**100 MARSAC AVENUE SUBDIVISION**

**COMMENTS SUBMITTED  
NOVEMBER 3, 2008**

**BY PETER BARNES AND JAMIE THOMAS**

## ***100 Marsac Avenue Subdivision application***

Extract 1911 survey being  
 "a true, and correct copy of a map made by Charles P Brooks and filed with the Co  
 Recorder Aug, 3rd 1880"

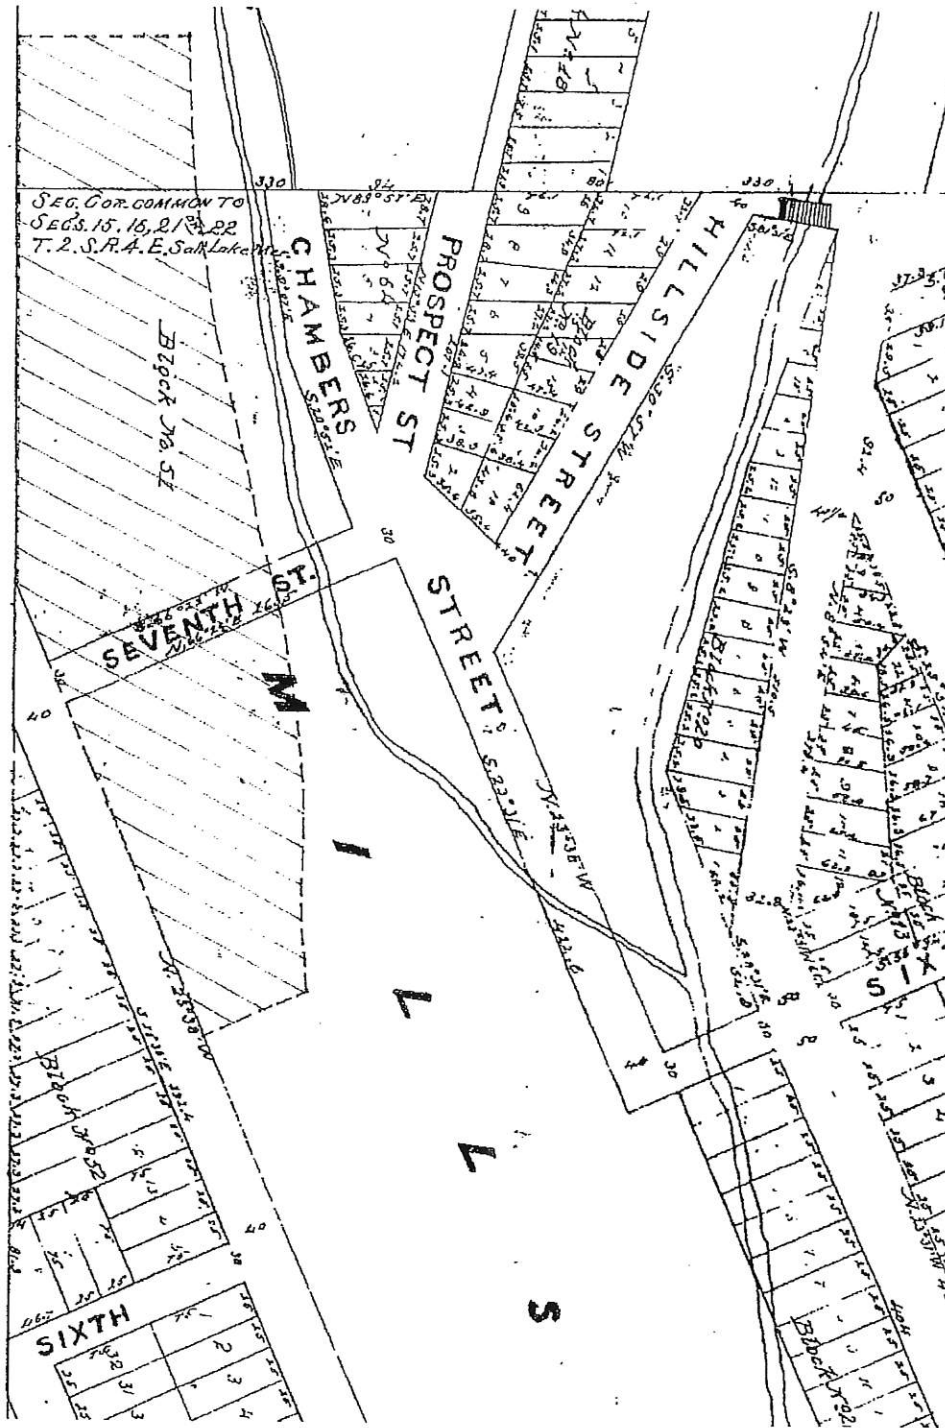
*This project fails both criteria.*

*\*At the Planning Commission meeting of October 22<sup>nd</sup> Planning Staff contended that despite evidence to the contrary the project is in fact located outside the Park City Survey.*

*\*The idea that the project is located within the Park City Survey was reached by reference to the official Park City Monument Survey of 1982 "...intended to be used as reference points for the Park City Survey and Snyders Addition Survey Plats". Further justification was reached by consultation of the 1911 City map "...a true, and correct copy of a map made by Charles P Brooks and filed with the Co Recorder Aug 3<sup>rd</sup> 1880." Extracts attached.*

*\*It is difficult to see why one holding the reasonable opinion that the project thus be considered "a part of the Park City Survey" should be treated as if 'repeating a lie'.*
